Santos NSW (Eastern) Pty Ltd - NARRABRI GAS PROJECT

Expert Review of Environmental Impact Statement, including the Response to Submissions

28 June 2018

Andrea Broughton, Groundwater Solutions International

Figure 4-3 Hydrograph for monitoring bore BWD6 (Porcupine Formation)

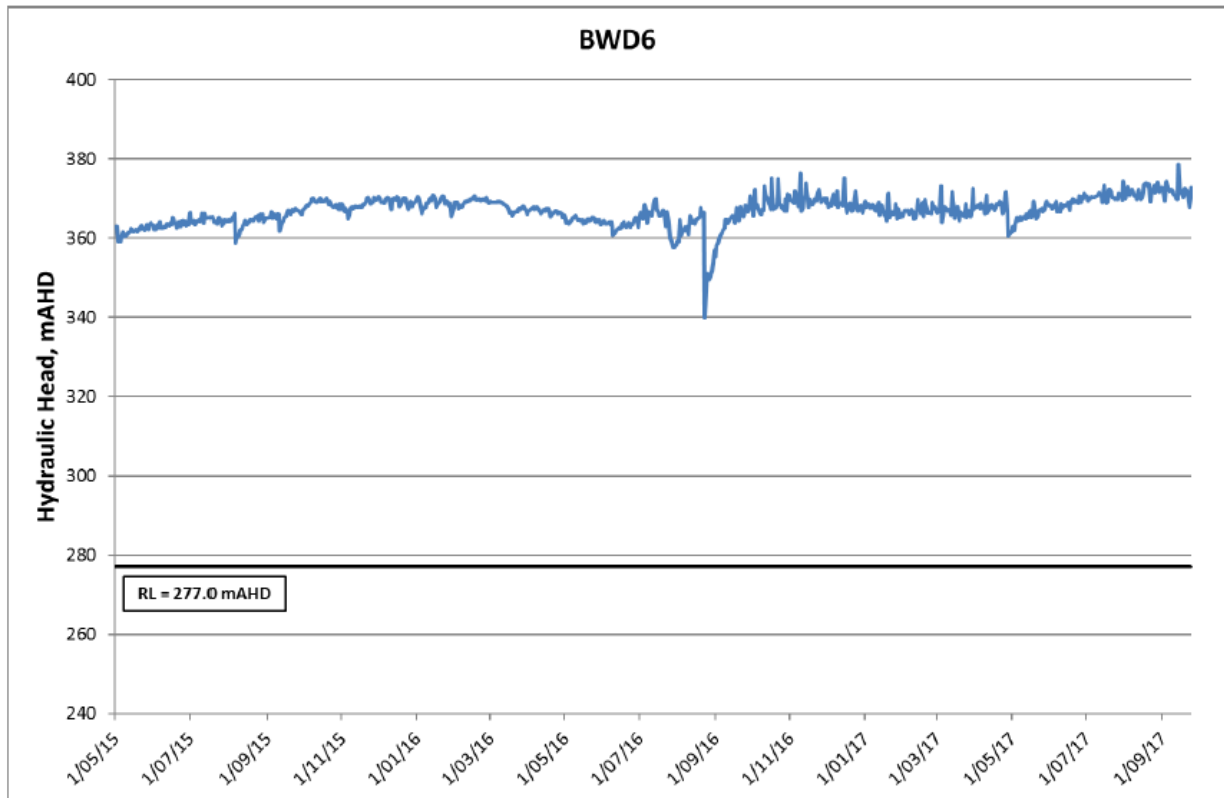
The baseline dataset is not representative of the temporal variation in groundwater pressure head in the GOB bores. It can take a number of years for the deep HSUs to show the effects of a drought (a lag effect). Therefore, predictions using a numerical model based on a lack of temporal variation will not predict realistic drawdown effects in the deep HSUs as a result of drought conditions during CSG dewatering, where the recharge is less, surface water sources are less available and likelihood of increased groundwater pumping. However, DPI bores do achieve this.

This point is still valid for the deep GOB and GAB HSUs. All six bores have at least two years of continuous monitoring but I do not consider this to be representative of temporal variation in hydraulic head (groundwater pressure) in the deep GOB and GAB bores. Please note that the data entry in Table 4-1 (shown below) for Bore BWD6 is incorrect, as the data presented in Figure 4-3 below indicates data has been collected continuously until at least 01 September 2017.

Santos' predicted early depressurisation estimates were realistic. However, in my opinion these depressurisation estimates cannot be predicted with the present incomplete baseline dataset for the GOB and deep GAB HSUs.

Figure 4-7 Hydrograph for monitoring bore DWH14PRPUR03 (Purlawaugh Formation)

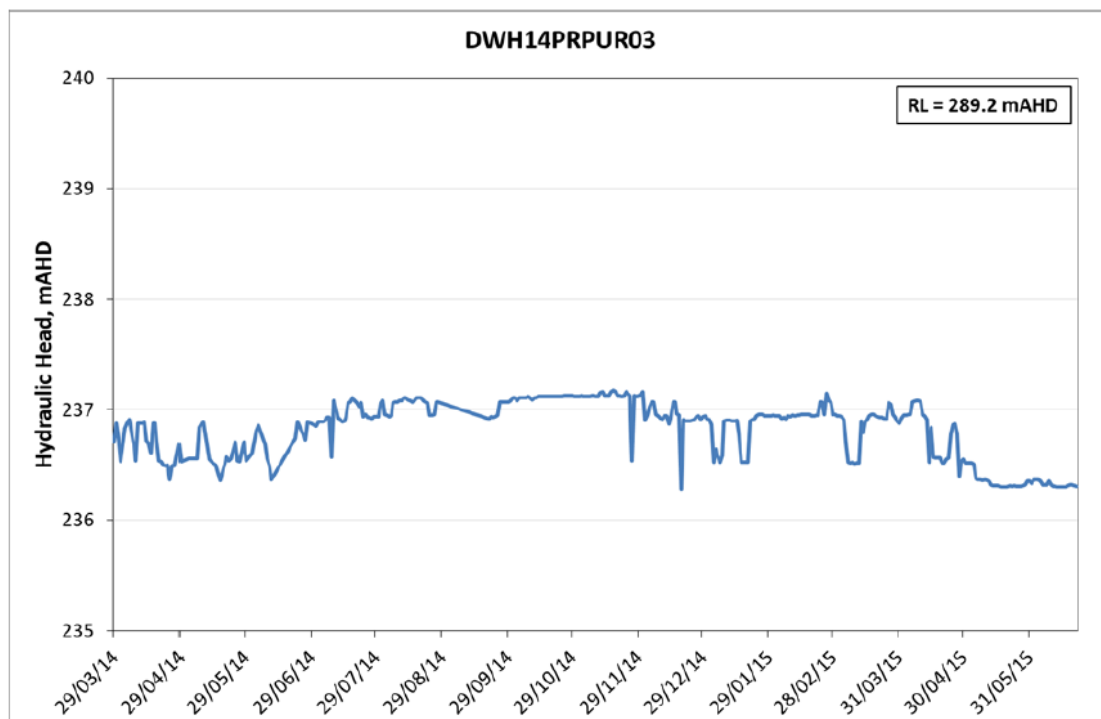
Only two bores represent the basal Jurassic Purlawaugh Formation aquitard, DWH14PRPUR03 and BWD28QGPUR01. DWH14PRPUR03 has data for just over one year only which is not a sufficient baseline dataset against which to compare future data.

This point is still valid. Given DWH14PR nested pipes for the Upper and Lower Pilliga are continuously monitored from 2014 until the end of 2017, it is unclear why has the nested pipe for the Purlawaugh Bed aquitard only been monitored for one year (refer to Figure 4-7 below). Groundwater level variation may be small, but it still provides insight into hydraulic pressure head variation when compared with other formation hydrographs. Baseline information from this aquitard is critical for setting up baseline conditions in the numerical model, and for comparing

This comment has mostly been addressed as there are now two years of overlapping data, except of the Purlawaugh Bed bore. It is unclear why Santos has not and is continuing to not monitor DWH14PRPUR03.
